**MINUTES OF THE 144TH MEETING OF THE SEAC, KERALA HELD FROM
6TH TO 8TH JUNE, 2023 IN THE CONFERENCE HALL, STATE
ENVIRONMENT IMPACT ASSESSMENT AUTHORITY, KERALA**

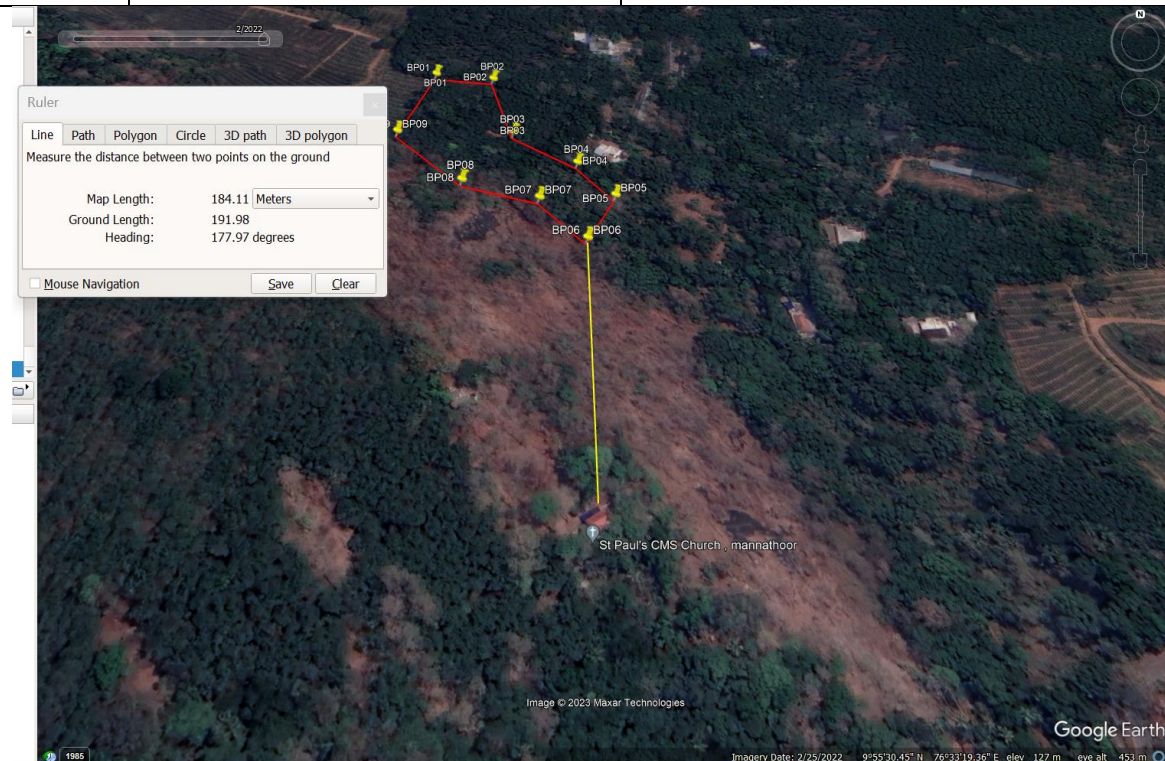
Five complaints (annexure-1 to 5) were received against the quarry and in general against the quarrying operations in the Thirumarady Panchayath. The subcommittee studies the complaints and found that most of them repetative and very general. The details are given below;

Sl. No.	Complaint	Status
1	Landslide happened in the upper portion of the site	Not found any scar of the landslide/slip. The upper portioin of the site is rocky terrain and a few indigenous trees are present at the regions where top soil is present
2	>80 ⁰ slope
